ADDENDUM NO. 1
1st Ave S / 7th St S SIDEWALK REPAIR AND STREETSCAPE O.F 1786.2
AUGUST 15, 2025

NOTICE TO ALL BIDDERS

Attached specifications for the period lights and foundation.

1 **FIXTURE TYPE H1 AND H2 BASE DETAIL**
SCALE: NO SCALE

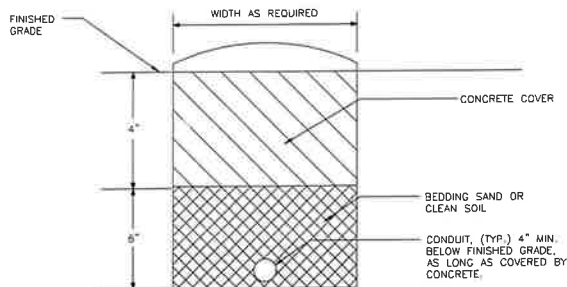
3. What is the light foundation size and what are the reinforcing details? **(See attachments)**
4. It appears the new lights will be going in sidewalk, like they are on the west side of the street. Will the sidewalk be wide enough for ADA concerns? **(Yes)**

2 **TYP. UNDERGROUND BRANCH CIRCUIT TRENCH DTL**
SCALE: NO SCALE

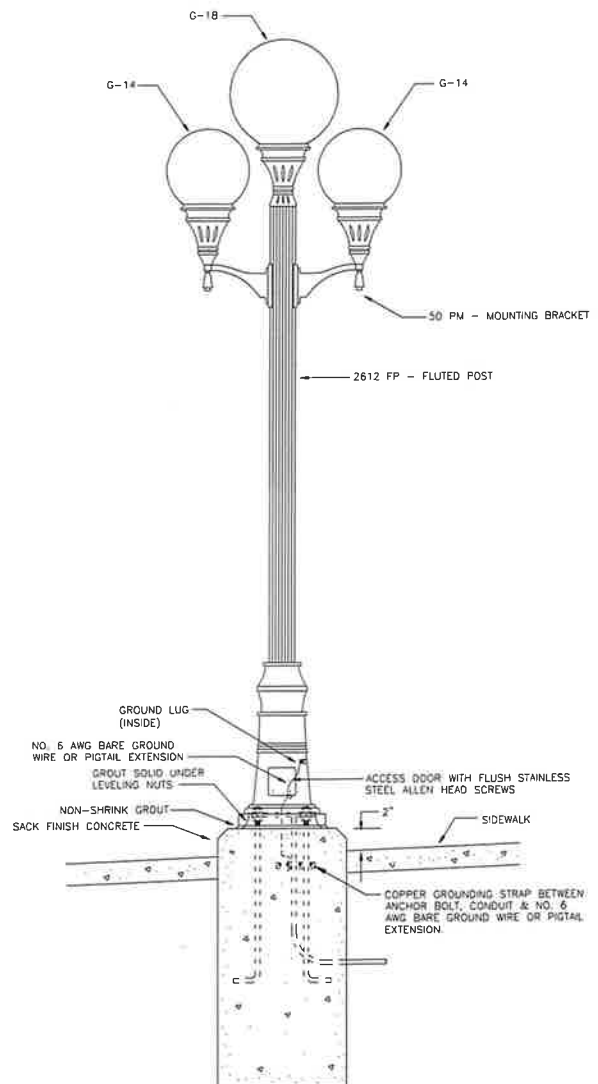
2. How is power to be brought to the lights? **(That is up to the contractor)**
 - a. What size conduit? **(1 ½ inch)**
 - i. What is the routing of the conduit?

1. Bored across 7th? **(Will not cross 7th, will come from the the O'Haire Inn side)**
 2. Under the new sidewalk? **(under new curb line)**
 - b. What size wire? **(10 gauge)**

3 **FIXTURE TYPE H1 MOUNTING DETAIL**
SCALE: NO SCALE

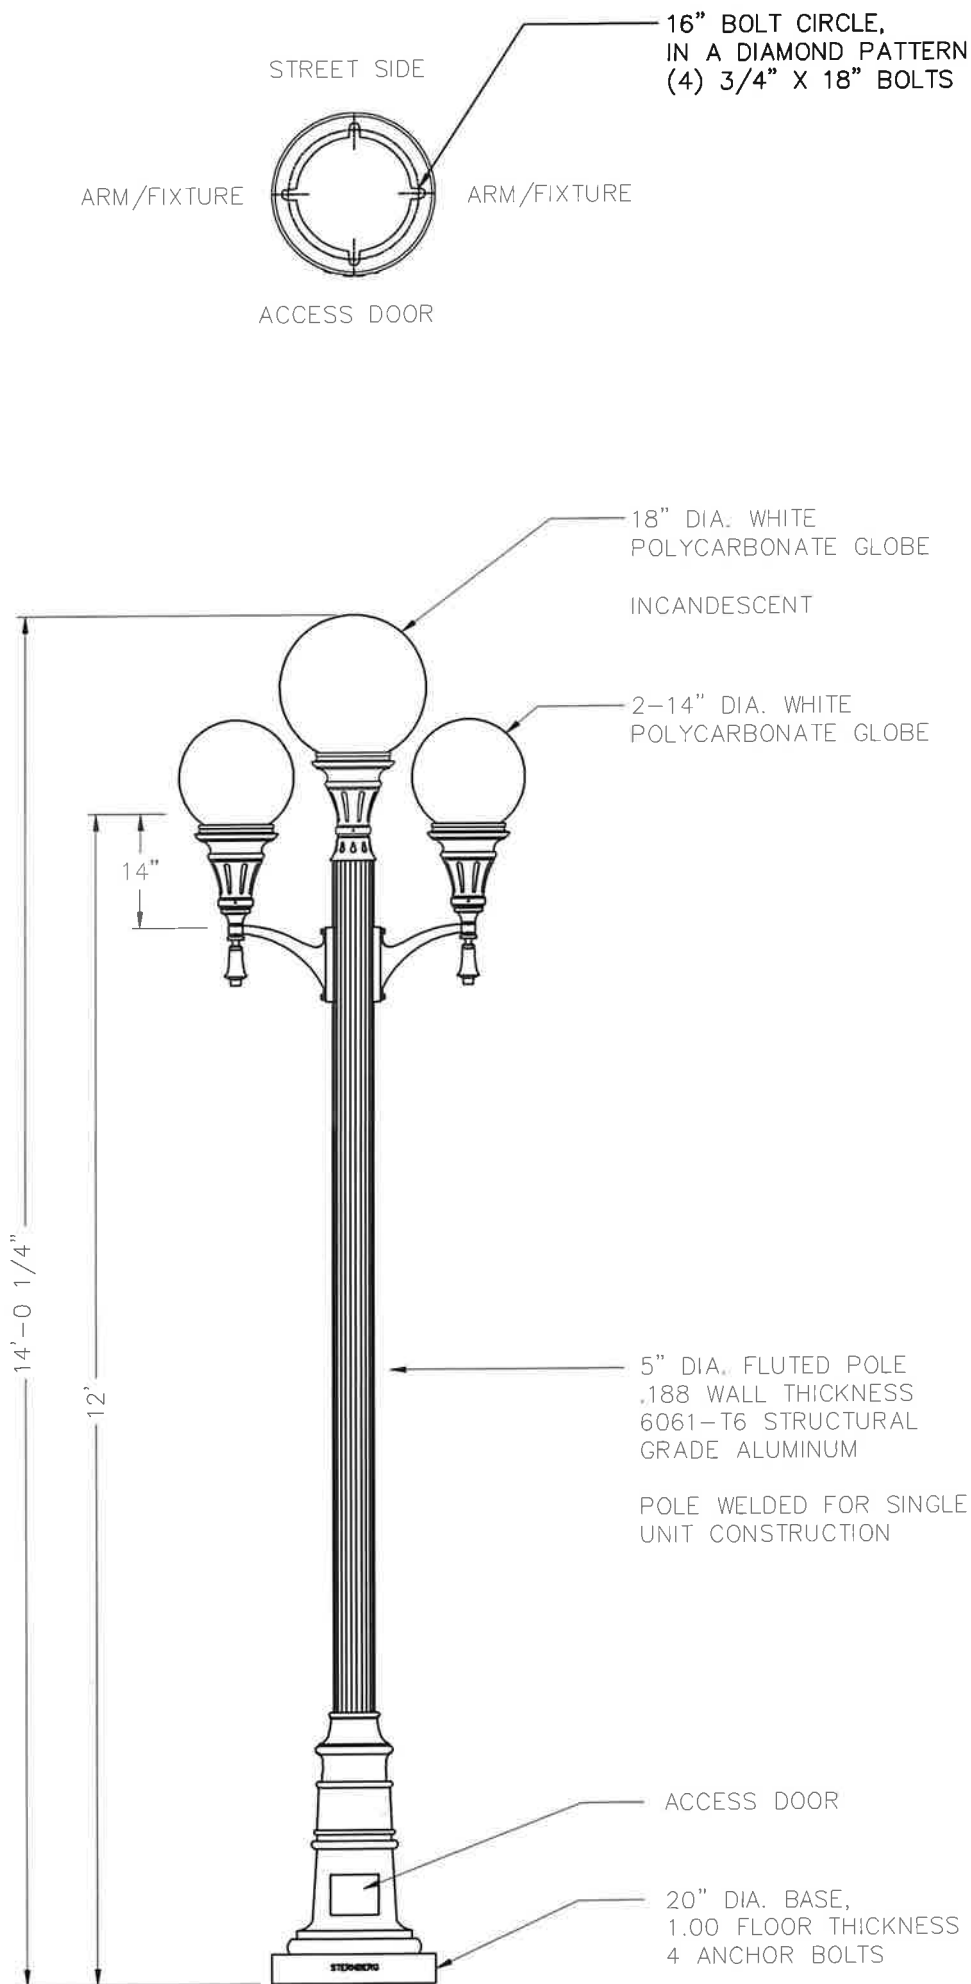
5. What are the specifications for the poles & fixtures?
 - a. Thank you for the handout, can you send me a digital copy? **(yes)**
6. Is the removal of the existing, OH fed lights by others (power company)? What, if any, of this scope is by the contractor? **(Northwestern will handle it, the contractor will have to work with them)**
